PANTERA TECHNICAL SERVICE BULLETIN

BULLETIN NO. 14

HEADLAMP RELAY (CLEAR PLASTIC COVER)

Fig. 16 - Article No. 116

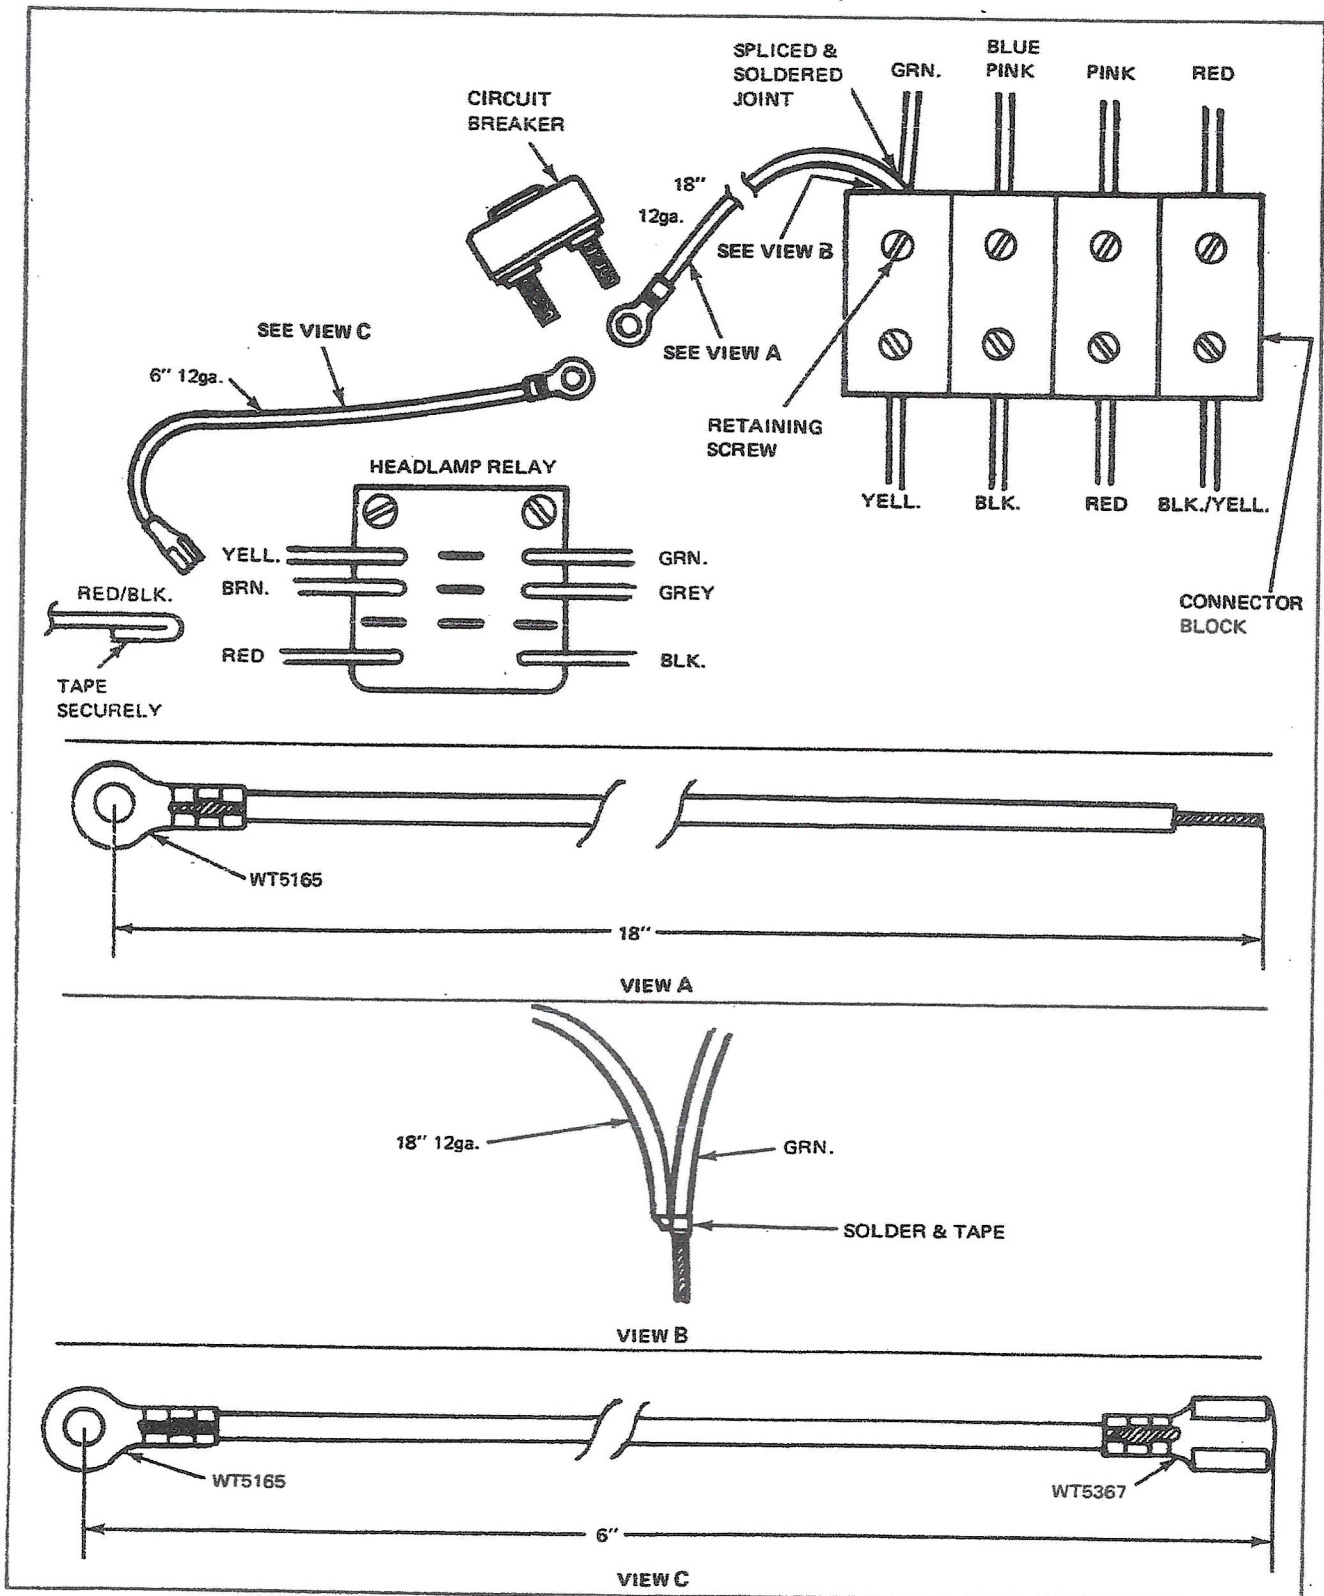
42. Fabricate piece of 12 gauge wire 6 inches long. Crimp and solder eyelet terminal to one end and female terminal to the other end. (See Fig. 16 - View C).

43. Attach eyelet terminal to other post on circuit breaker and install No. 10-24 nut. (See Fig. 16) Using electrical tape, carefully wrap wires and circuit breaker terminals.

Fig. 17 - Article No. 116

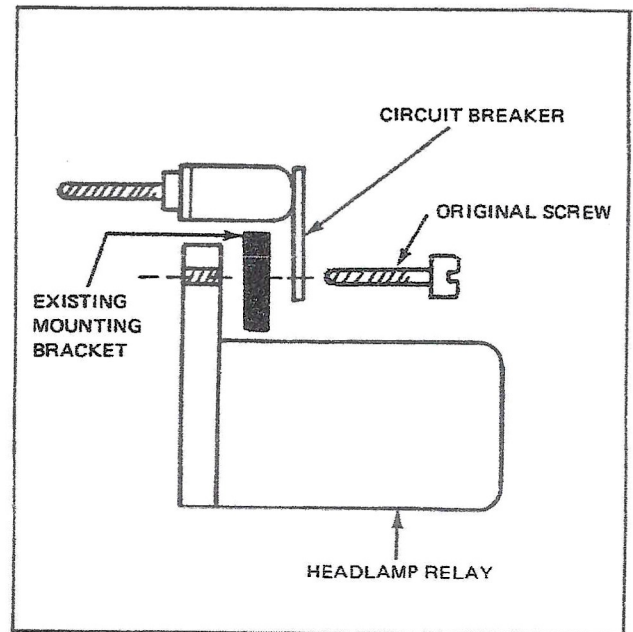
48. Place circuit breaker in position at forward screw hole with terminals facing rearward and install circuit breaker and headlamp relay to mounting bracket original screw. (See Fig. 17)

Fig. 18 — Article No. 117

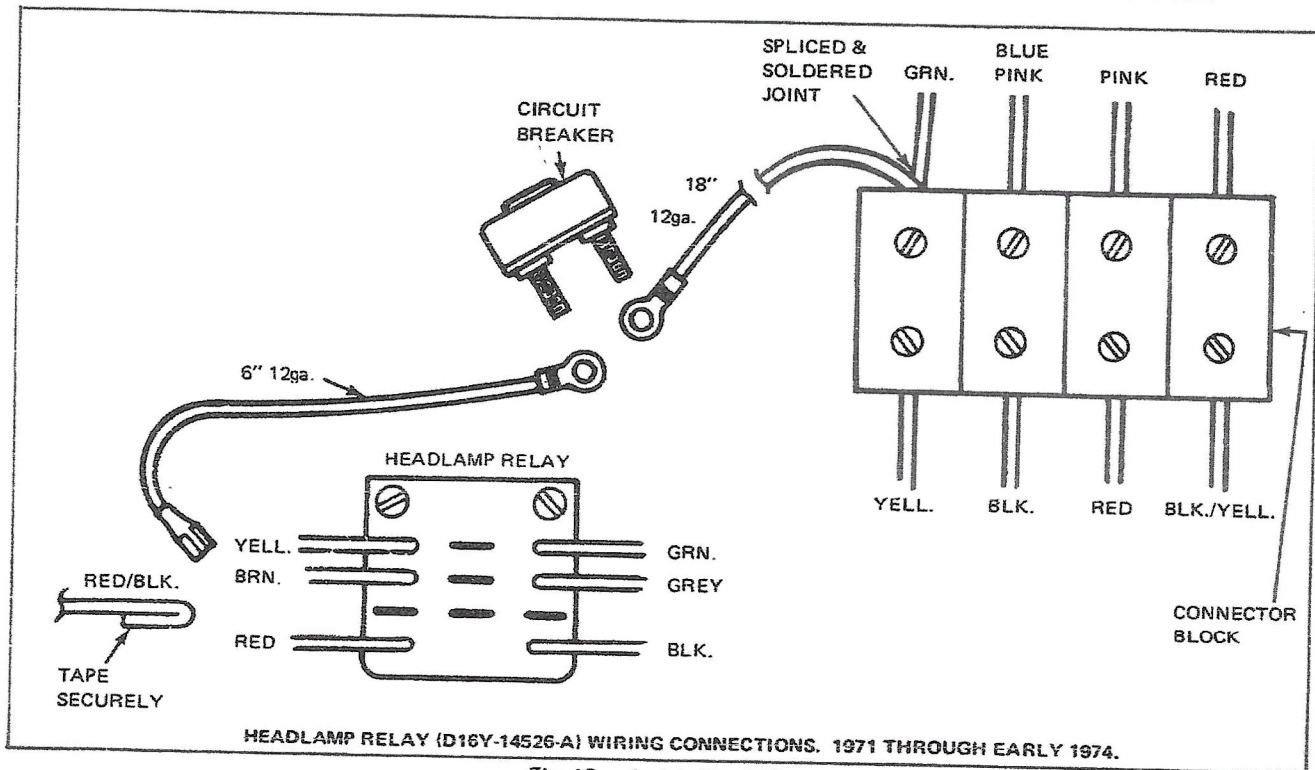
The relays, while identical in visual appearance, are not interchangeable due to internal design changes.

In the vehicles the type of relay required can only be determined by an examination of the wiring connections as shown in Figs. 18 and 19.

Fig. 20 — Article No. 117

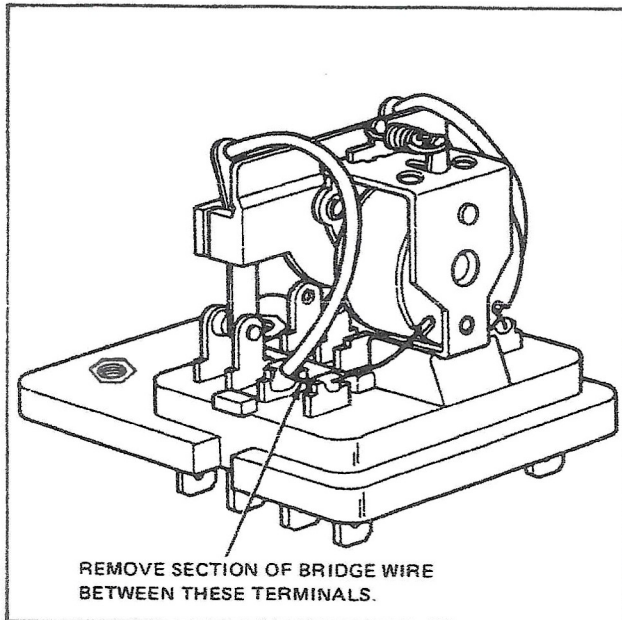
The D16Y relay has a bridge wire connecting the two ground terminals. The D46Y relay does not have the bridge wire between the terminals. D16Y relay can be converted to a D46Y type relay as follows:

2. Remove the bridge wire connecting the two (2) ground terminals, (see Fig. 20) and replace the cover.
